NUCLEAR ENERGY INSTITUTE

Seismic Screening Criteria
for
Assessing Potential Fuel Pool Vulnerabilities
at
Decommissioning Plants

December 13, 1999
Revision 1

Comments on NRC Draft Screening Criteria for Assessing Potential Seismic Vulnerabilities of Spent Fuel Pools at Decommissioning Plants – December 3, 1999 NRC Memorandum

Figure 1

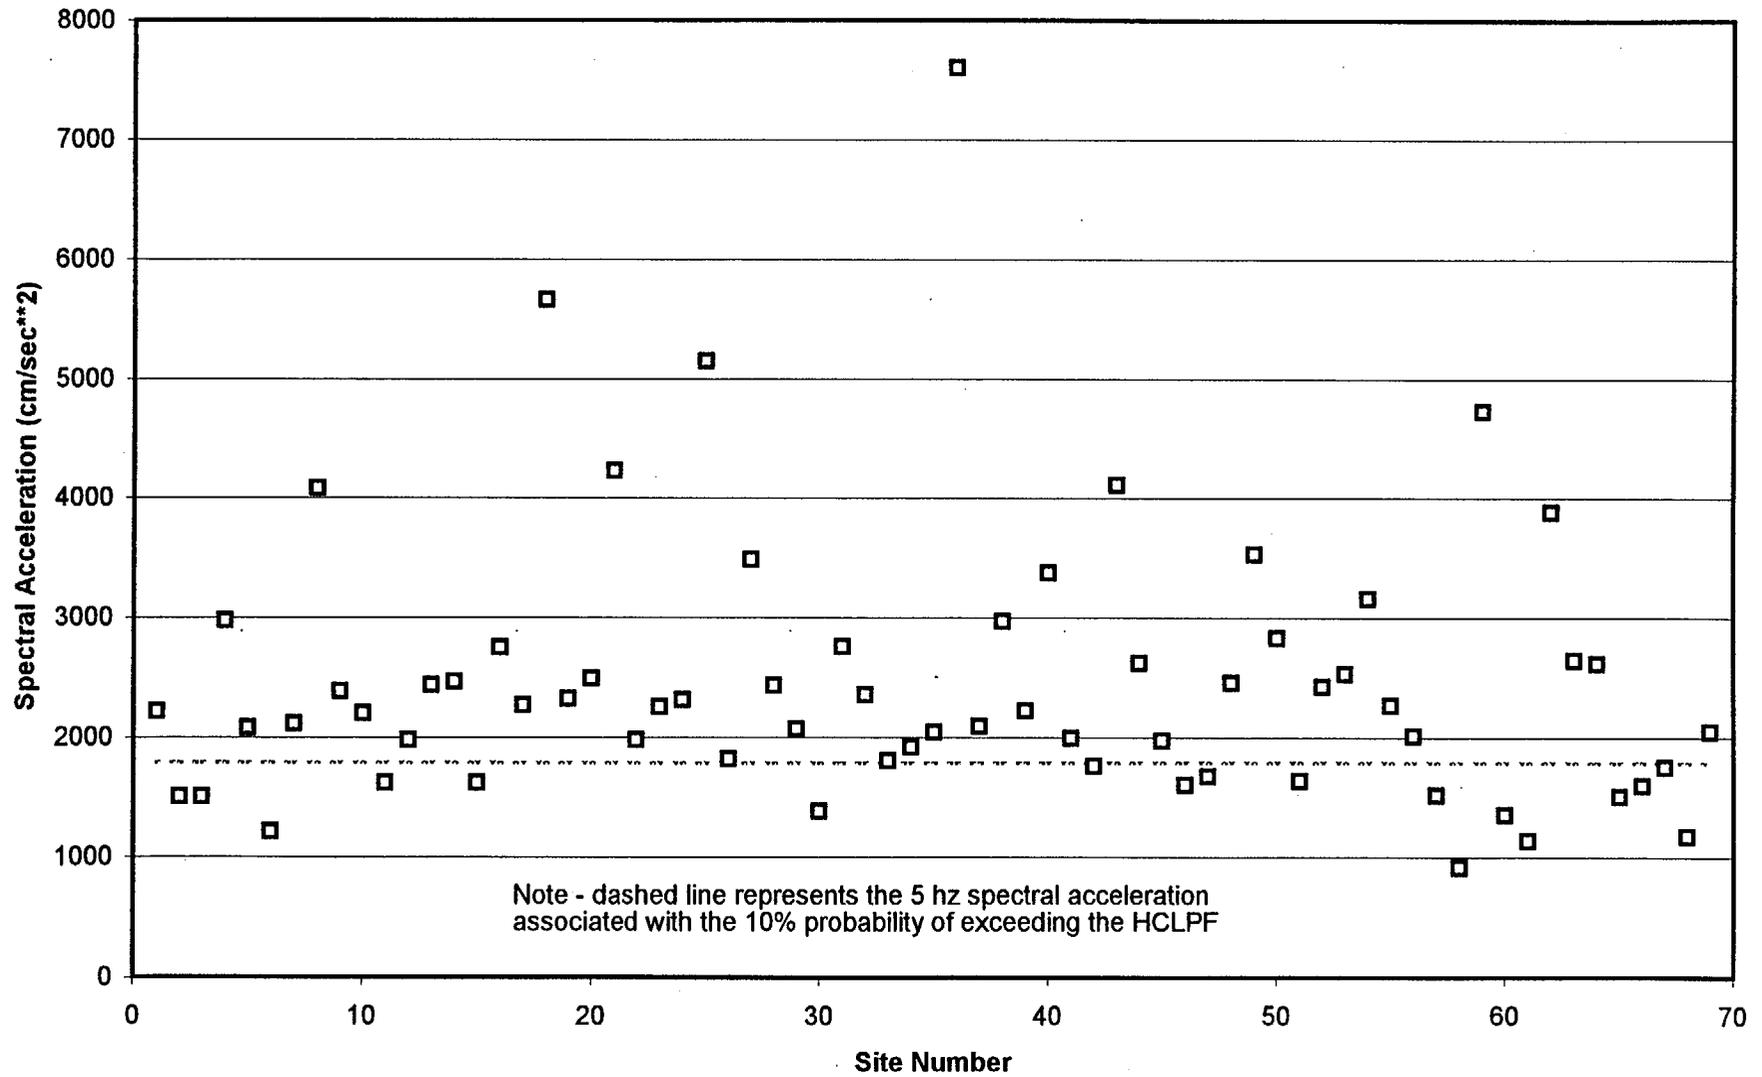
5. For a site to be screened out the $C_{10\%}$ value should be on the order of 10^{-6} . Figure 1 (attached) shows the 5 Hz spectral acceleration values associated with the 10^{-6} LLNL results at each of the 69 sites. As can be seen, for site number 36 (which in Table 3 of the Kennedy report is the site with the highest SFP failure frequency) the 10^{-6} spectral acceleration is about 7,700 cm/sec² or about 245 cm/sec. As stated previously, 57 cm/sec is consistent with 5 Hz spectral velocities associated with a magnitude 6.6 earthquake 8 km from the site (San Onofre SSE), therefore these predicted groundmotions must be associated with a very large earthquake, greater than magnitude 6.5, very near to the site – which is counter to the conclusions of SECY-91-135. Other values at other sites are equally incredible. Based on these results, it is concluded that the LLNL results, at the probability/ground motion levels of interest, are deterministically incredible and therefore their use in screening is questionable. Figure 2 (attached) shows the 5 Hz spectral acceleration values associated with the 10^{-6} EPRI results. As can be seen, the EPRI results, at the probability/ground motion levels of interest, are credible, and consistent with SECY-91-135.

Figure 3

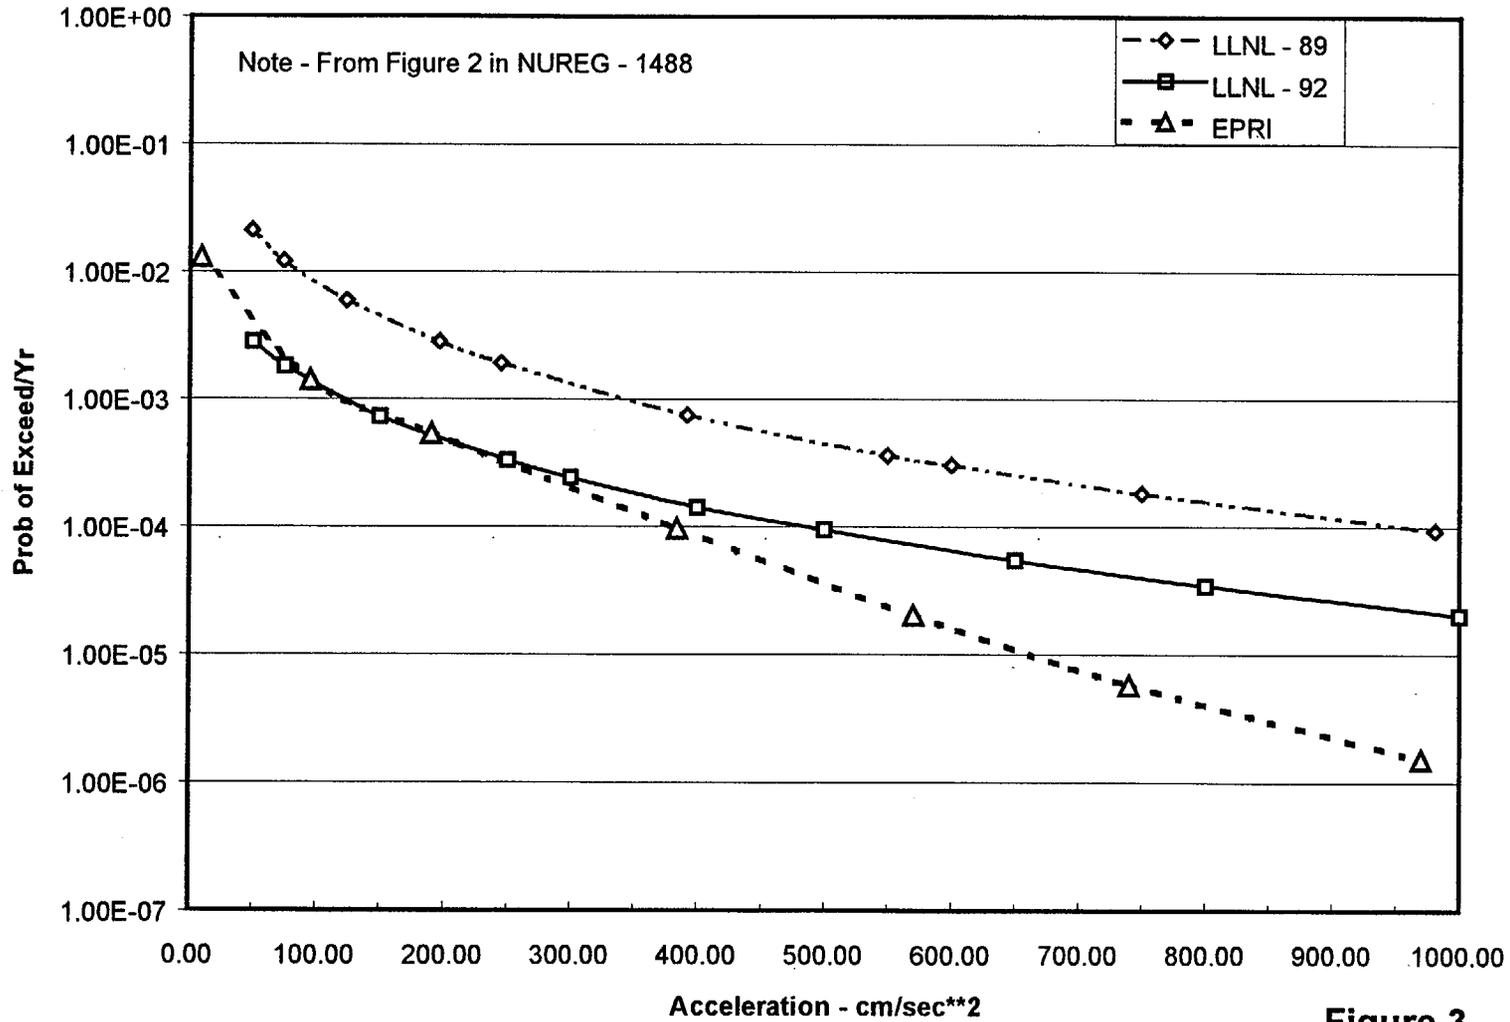
6. Figure 3 (Figure 2 from NUREG-1488, Reference 5) illustrates the problems associated with the LLNL results at high ground motions/low annual probabilities. As can be seen from Figure 3, at high probabilities there is reasonable agreement between LLNL and

EPRI. However, the slope of the LLNL results at high ground motions is too shallow. The effect of this shallow slope is to predict incredible ground motions at credible probability levels.

Figure 4

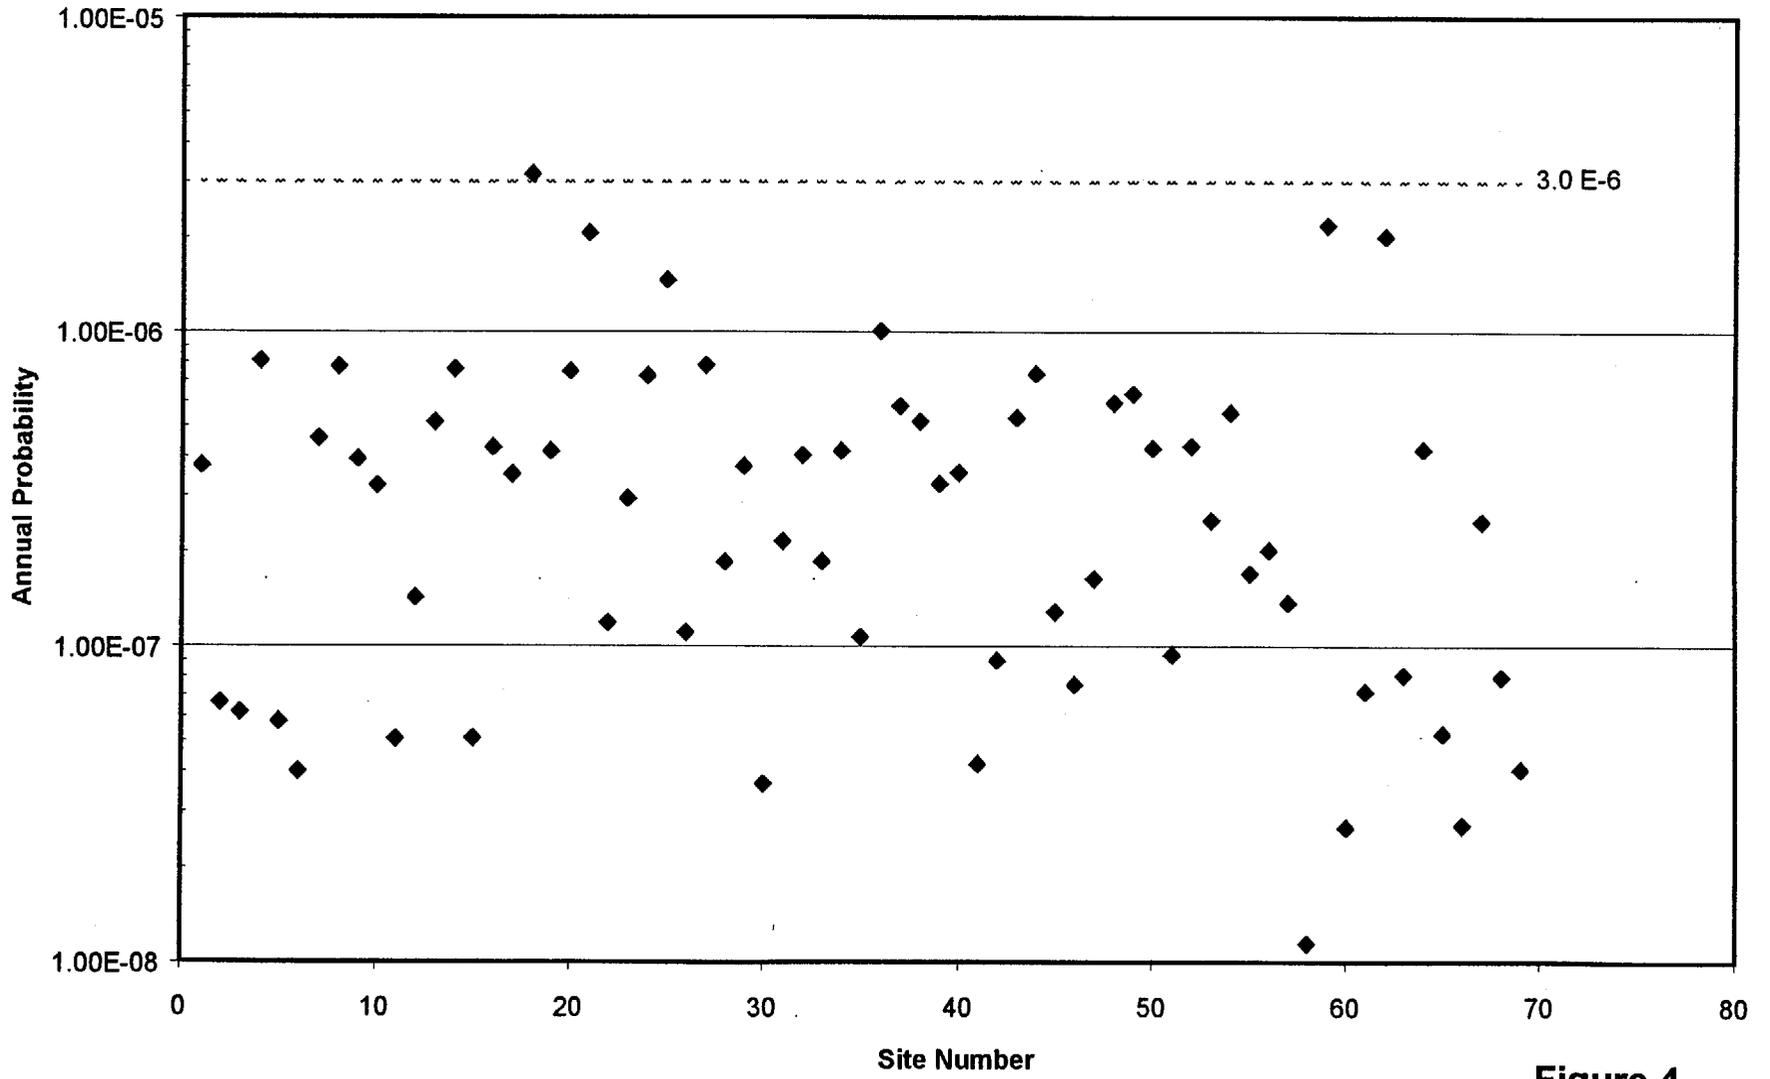
7. Based on this review, industry contends that it would be appropriate to only use EPRI results in the SFP seismic screening analysis. We believe this to be reasonable in light of the difficulties associated with the LLNL results at low probabilities. The effect of using only the EPRI results is shown in column 3 of Table 3 in the Kennedy report (Reference 1). As can be seen, only 1 plant would be required to perform further analyses. However, because both LLNL and EPRI are considered to provide valid results, it is proposed that the results from each study be geometrically averaged such that equal weight is provided the results from each study. Arithmetic averaging is considered unacceptable in light of the difficulties associated with the LLNL results. Figure 4 provides the results of geometrically averaging the LLNL and EPRI results.

Based on Figure 4 about 6 sites would be preliminarily screened in due to exceeding the 10^{-6} criterion. One of the 6 sites is Shoreham. If these screened in SFPs are above ground then further analyses will be required.
